REPORT AMENDED BY CPC 9-24-87
CITY PLANNING COMMISSION

APPLICATION: Plan Review to allow construction of two warehouse/office buildings totaling 103,680+ square feet on 5.03+ vacant acres in the Light-Industrial-Review (M-1(S)-R)

APPLC. NO. P87-292 **MEETING DATE:** 9-24-87 **ITEM NO.** 5
~~8-29-87~~
9-10-87

SITE PLAN

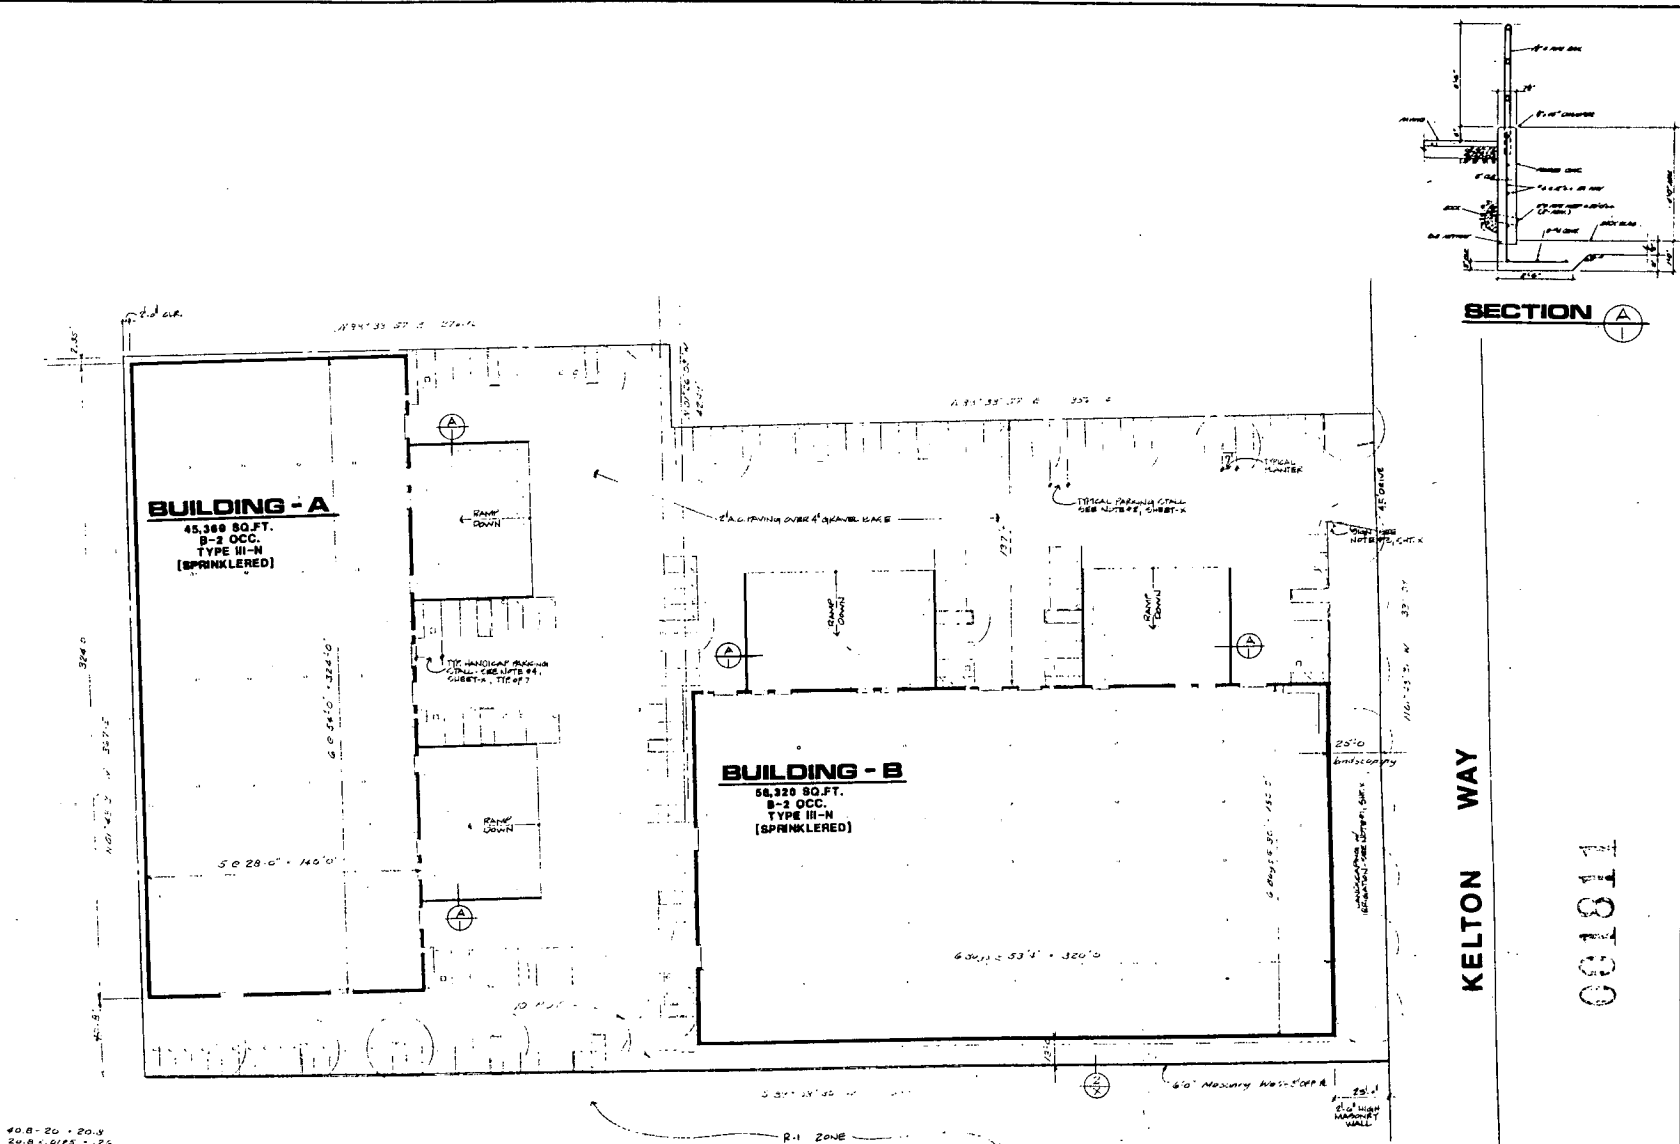
Staff has several concerns over the proposed project which will require site plan modification. (Refer to Exhibit A, staff modified site plan).

1. Setbacks: The proposed buildings are very massive with 29 feet of height. In order to buffer the wall effect from the residential properties to the south, staff recommends increasing the setback along the south property line to 25 feet from the proposed 13 foot setback for building B. Staff also recommends extensive landscaping with evergreen trees on 20 foot centers consisting of redwood and pine trees. Groundcover should be turf with a walkway and employee break areas established. Trees shall a minimum of five gallon size. The 25 foot landscape strip shall run along the entire south property line.

The building setback along Kelton is proposed at 25 feet. Staff observes that the Havlin - Witkin building is setback approximately 88 feet from the setback edge. Staff recommends that building B be setback 50 feet or more. The applicant suggested that in order to maintain a 25 foot building setback along Kelton Way, that he is willing to reduce the height from 29 feet to between 10 and 15 feet for the storefront window panels and install a sloping roof back to the 50 foot setback line where the height of the wall would be 29 feet. The revised site plan and elevations should show one of the two alternatives.

2. Wall Requirement: The Zoning Ordinance requires a minimum six foot high solid masonry wall separating residential from non-residential uses. Staff field inspected the site and noted that Kanowsky Furniture, locate due west of the site has an eight foot high solid wall. The wall is located at the original base grade elevation with the parking lot finish grade elevation nearly four feet higher so that the effective wall height is only four feet. Staff recommends that the new six foot high wall be constructed at the top of the fill slope or on top of a retaining wall. The six foot height of the wall shall be measured from the warehouse side grade elevation. The wall of the building will also provide a buffer for any potential noise from the north side of the building.

3. Reorient Building A: Building A has two proposed below grade loading docks which will generate noise to the residences to the south. Staff recommends that building A be reoriented so that the loading bays face to the north. The building will be required to observe the storm drainage easement. Landscaping is recommended between the two buildings. In turning the building the rear wall will serve as a noise barrier.

4. Landscape - North Property Line: Staff reviewed the landscaping and recommends a 10 foot wide landscape strip along the north property line to be planted with trees, shrubbery and living ground cover. A six foot high decorative wrought iron fence is recommended to provide security and an aesthetically pleasing transition to the residential area along Kelton Way and up to the Havlin Witkin setback. Chain link fencing is appropriate for the remaining north fence line. Parking along the north property line shall include a two foot vehicle overhang into the landscape strip. No portable concrete wheel stops will be allowed. All landscape areas are to be bordered by a six inch raised poured in place concrete curb. Razor ribbon wire shall not be used. Due to the truck loading dock locations opposite a row of parking along the north property line, the normal 105 foot distance required for a semitruck-trailer combination movement would be reduced to 99 feet. Staff recommends the total landscape width along the north property line opposite Building B's loading docks be six feet in width and that the spaces be reserved for compact cars only. This would maintain the minimum 105 feet for vehicle maneuvering with the repositioning of Building B to the north by 12 feet. Refer to Exhibit A for the location of the reduced landscape planter.

8. Parking Lot Fingers: In revising the site plan, staff recommends that no more than 15 consecutive parking spaces be shown without installation of tree well finger planters. The fingers will break up the long monotonous appearance of parking spaces without variation.

9. Trash Enclosure: The revised site plan shall include trash enclosures meeting trash enclosure guidelines. Trash enclosures are to be located more than 100 feet from residential uses.

1. The applicant shall prepare a revised site plan, landscaping and irrigation plan for review and approval by the Planning Director prior to issuance of building permits (Refer to Exhibit A).

EAST ELEVATION

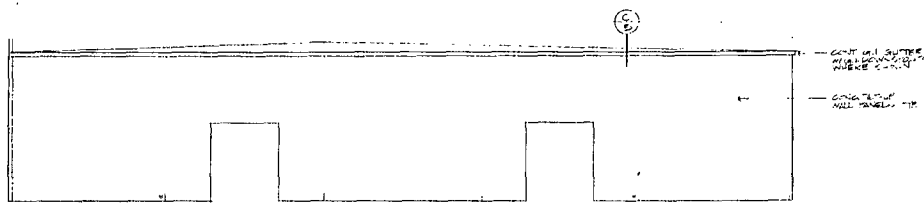
1. Building B - East Elevation

The 180 feet of Building B facing Kelton Way is stark, bland and uninteresting. Staff recommend the applicant redesign the east elevation to have more three dimensional relief by adding store front windows and either project or recess them with use of awning or canopy feature so that the wall has movement and interest. Windows shall be reviewed and approved by the design review coordinator.

Staff also notes that no relief is proposed on the concrete panels. Staff recommends the applicant incorporate a two to three foot high formliner along the top elevation of each panel with two, three inch wide, one inch deep reveal lines. The formliner and reveal bands are to circle the buildings. In addition, all walls facing the south property line shall include vertical bands or relief features at each joint. The vertical feature may be painted a trim color compatible with the overall project.

2. The applicant shall revise the exterior elevations to the satisfaction of the Planning Director and Design Review Coordinator. All colors and material are to be included in the revised elevations.

35. *The eastern exterior wall that faces Kelton Avenue and the end panels on the north and south side shall be exposed aggregate. (CPC added)*
 36. *The applicant shall eliminate the driveway access onto Kelton Avenue and provide access from Main Avenue if the applicant or the local residences are able to obtain an easement for ingress and egress across the property to the north from Main Avenue. (CPC added)*

EXHIBIT A

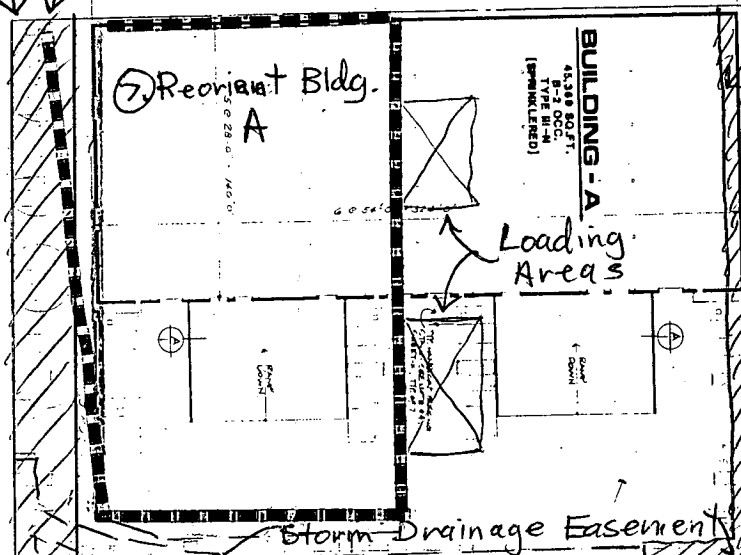
- ① Add 6 ft high solid decorative masonry wall
- ② Add 25 ft wide landscape strip along South property line,

- ④ Add 10 ft. landscape planter strip along North property line - Reduce planter width to 6 ft. opposite truck loading bay's.

- ⑤ Add 6 ft high decorative wrought iron fence along North property line

- ⑦ Construct 6 ft chainlink fence behind Havlin-Witkin setback

- ⑧ Add 10 ft high wingwall length of Truck dock

- ⑥ Add wrought-iron security gate-roll type & Fence along Kelton behind 25 ft Setback or along wingwall

- ③ Increase Building Setback to 50 feet - Minimum of 25 feet landscaping from Kelton Way or reduce height of building to 12 to 15 feet at 25 ft. setback and increase to 29 ft. height at 50 ft. setback.
